Numbered items are comments raised by Heritage Officer (September 2020).

Comments in **bold** are a summary of discussions from meeting on site with Tim Murphy (Place Services), Graham Keavill (Keavill Heritage Ltd) and Adam Harris (LSH Architects) on Tuesday 20th October 2020.

Job N	Drg N	Rev	Scale	Status	Job
18005	/ SK-84	A	As indicated	FOR INFORMATION	EDGE GROVE SCHOOL - STABLE BLOCK
Date	Director	Author	Check		Drawing
07/10/2020	JA	AH	--		REVIEW OF HERITAGE OFFICER COMMENTS

1 | Ground Floor Plan  
1 : 100

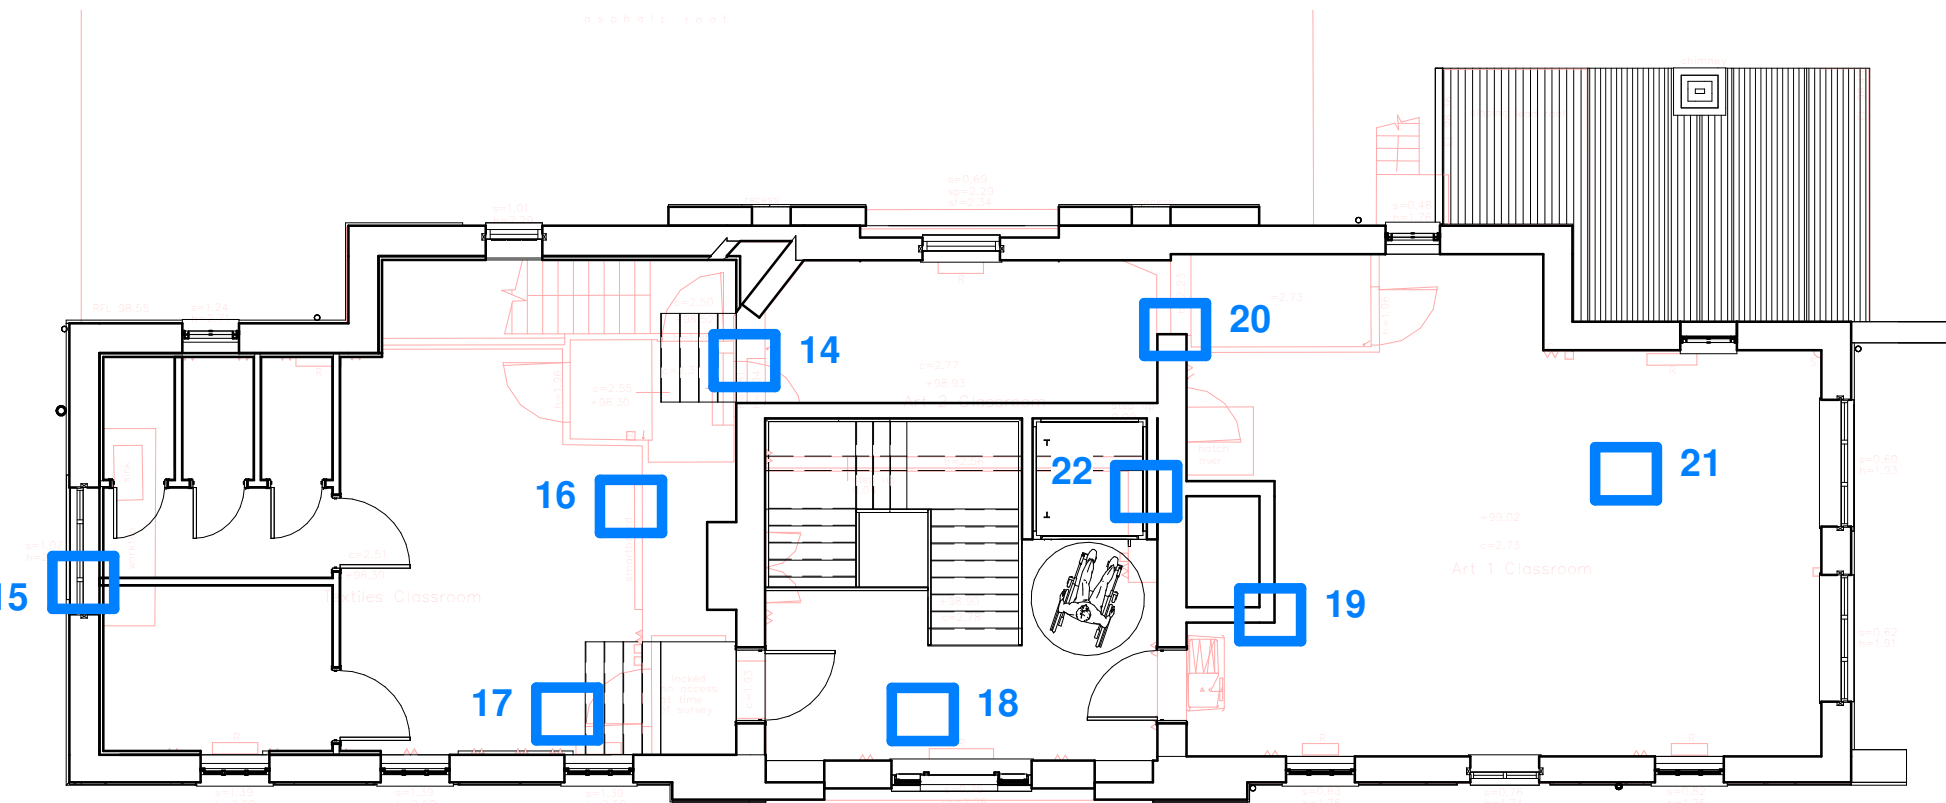
**GROUND FLOOR**

- (1) What age/value is this fabric? Was there a previous opening here to inform location of new opening?  
**GK confirmed there is evidence of existing opening in this location, most likely a window.**

**TM confirmed no objection to opening in this location.**
- (2) What age/value is this fabric? Why is the new wall not on the alignment of the structure?

**TM requested opening up in angled wall to ascertain age of fabric.**  
**GK to advise once photos of opening up received.**
- (3) Was there a previous opening here to inform location of new opening?

- (4) How will match-boarding be retained?  
**TM confirmed no objection to loss of match boarding seeing as stair is to be removed.**
- (5) How will iron column be retained?

**LSH to review how iron column can be retained.**
- (6) Appears all walls are to be lined?  
**LSH to review lining detail. Description / drawing required to avoid condition.**

- (7) What age/value is the ceiling fabric?  
**TM confirmed no objection to stair / lift opening in ceiling fabric in this area. See also Item 18.**
- (8) What age/value is this fabric? Was there a previous opening here to inform location of new opening?

**TM confirmed no objection to opening in this location.**
- (9) What interventions are needed to make this a kitchen? Lining of walls? Extractor fans? Bins? Storage?

- (10) How will this structure be encapsulated?  
**Match boarding to be retained within existing office. LSH to consider door position. Either through match boarding (jib door) or through external wall.**

- (11) What age/value is this fabric? Heritage statement notes it wasn't inspected.  
**TM & GK agreed there is no value to this area.**
- (12) What age/value is this fabric? Was there a previous opening here to inform location of new opening? What is the age and significance of boarding?

- (13) What age/value is this fabric? What's the justification for the loss of fabric and divergence from plan form?  
**LSH to consider retention of existing lintel and locked door. To be reviewed in conjunction with item 9a.**

**GK confirmed there is evidence of existing opening in this location, most likely a window.**  
**TM confirmed no objection to opening in this location.**

**TM confirmed no issue with modern partitions being removed. Highlighted store cupboard wall (9a) which requires further consideration. Opening up in ceiling above store required to review structure. GK to advise once photos of opening up received. LSH to consider retaining wall.**

**GK confirmed there is evidence of existing opening in this location, most likely a window.**  
**TM confirmed no objection to opening in this location.**

**FIRST FLOOR**

- (14) What age/value is this fabric? How will this relocated stair impact upon fabric and ground floor?  
**TM requested opening up in ceiling void. GK to advise once photos of opening up received.**

**LSH to consider creating suspended floor to create single level if possible.**
- (15) Plans appear to over-board this wall and to subdivide window.  
**LSH to consider amending partition to avoid window.**

- (16) Plans show significant alteration to this area without detail or justification.  
**GK advised there is a significant amount of modern surface treatment. LSH to consider removal of modern elements whilst retaining bread oven stack.**

- (17) How will new stair impact upon fabric both upon ground and first floor? Was there a previous opening in this location?  
**Potential for steps to be removed following Item 14. GK & TM agreed evidence (existing door frame) of existing opening from central classroom.**

- (18) What age/value is this floor?  
**TM confirmed no objection to opening in this location. LSH to consider retention of as much of the existing floor boards in central classroom as possible.**

- (19) What age/value is this fabric? How will extractor impact?  
**TM confirmed no objection to opening in this location.**
- (20) What age/value is this fabric?

- (21) Need to fully explore fabric – even if covered by fittings such as whiteboard.  
**TM raised concerns regarding lining on first floor. LSH to consider requirement for lining.**

- (22) New Item - Removal of existing chimney stack.  
**TM confirmed suitable method statement to be agreed with LPA regarding removal of existing chimney stack.**

**TM confirmed no issue with removal of cupboard partitions. LSH to consider retaining existing door frame in main wall (north / south) and potentially reusing door to cupboard.**
